## Item 8 - Correspondence

**From:** [pablo.collins](#)  
**To:** [MCP-Chair](#)  
**Subject:** Comments on 7500 Strathmore Sketch Plan, hearing 1-25-2024  
**Date:** Wednesday, January 24, 2024 11:04:54 AM  
**Attachments:** [Comments 7500 Strathmore.docx](#)

7500 Strathmore St  
Bethesda MD

Sketch Plan Number: 320240030

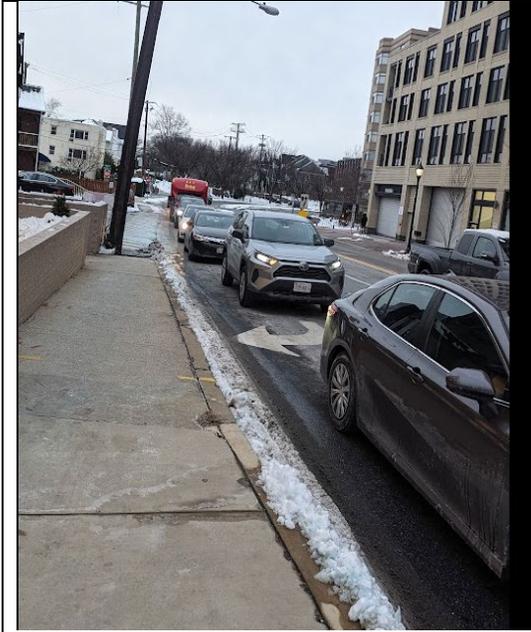
Is the developer or the county aware that during the evening rush hour eastbound traffic waiting for the light at Wisconsin often backs up beyond the Strathmore St entry into Woodmont, in contrast to Bradley which flows freely. (Pictures attached)

Exhibit A

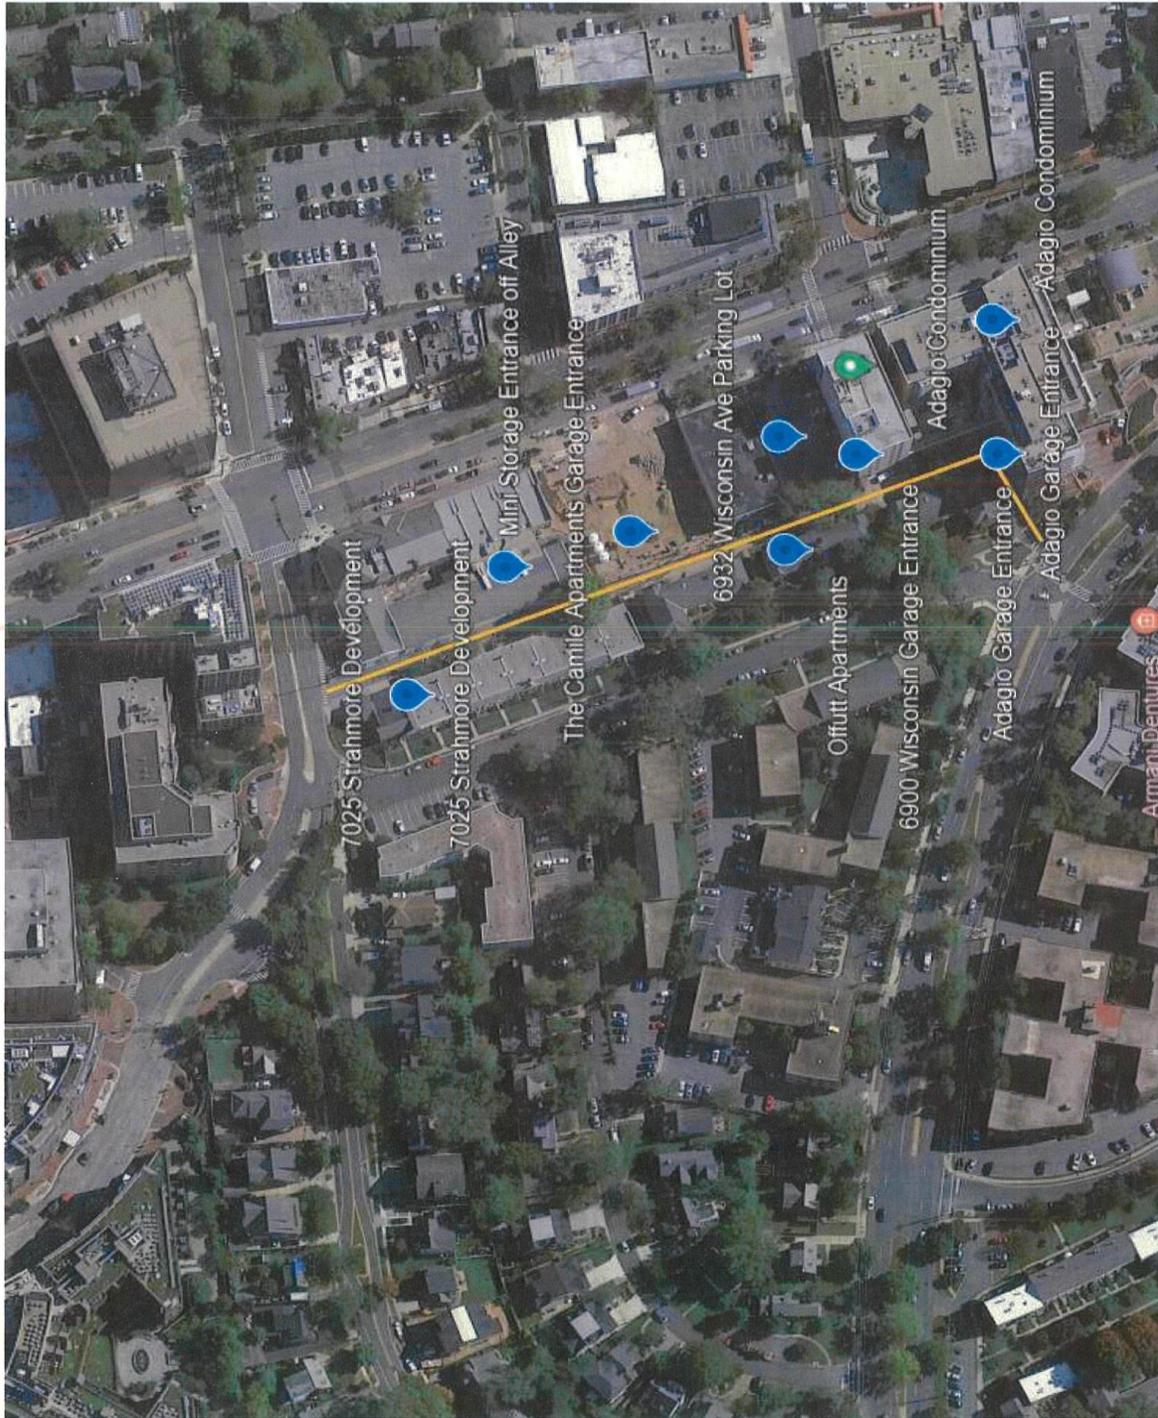
The construction of this project would result in significant traffic on the Service Alley behind the proposed development. See attached Exhibit A for alley location and Adagio's location relative to the Development and the numerous other Properties already using the Service Alley for Garage & Service Egress.

When completed, the proposed development would add another 150 parking spaces with Entrance/Exit to the alley, overloading an alley that is already overstrained with multiple residential and commercial properties using it. The attached Exhibit B shows pictures of all the existing Properties that use this Alley as a Garage and Service egress. Note how tight and restricted this alley is; adding another 300 car trips daily to it will be a burden to an already overused area.

Exhibit B

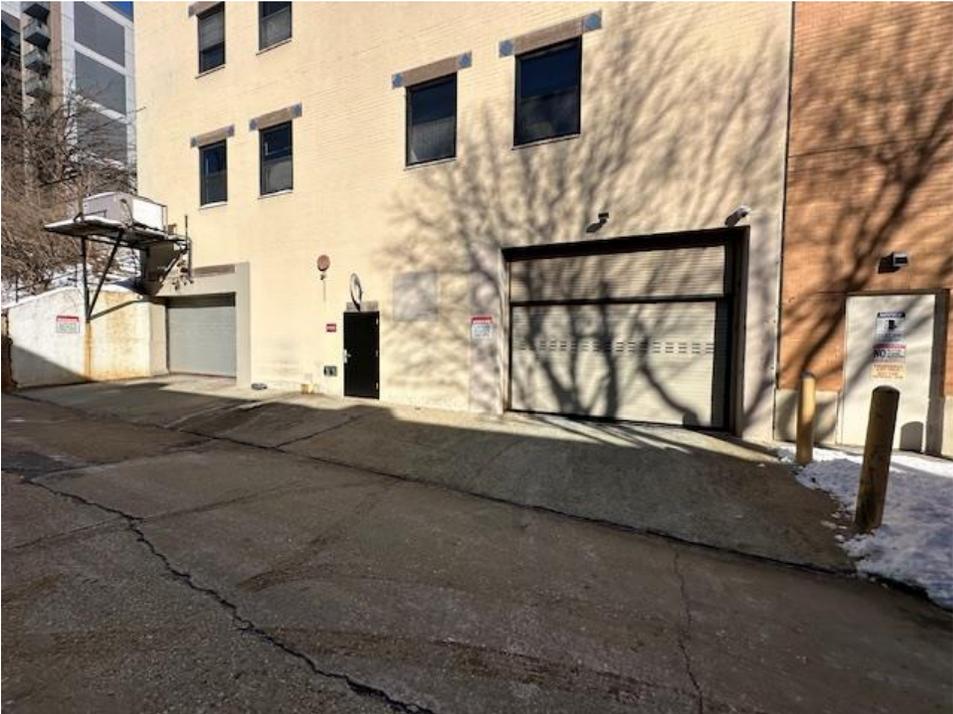
North View of Alley, 7025 Strathmore on West Side and Cube Smart Mini Storage on East Side. Per the Sketch Plan the 7025 Garage entrance and service area is almost directly across from this.
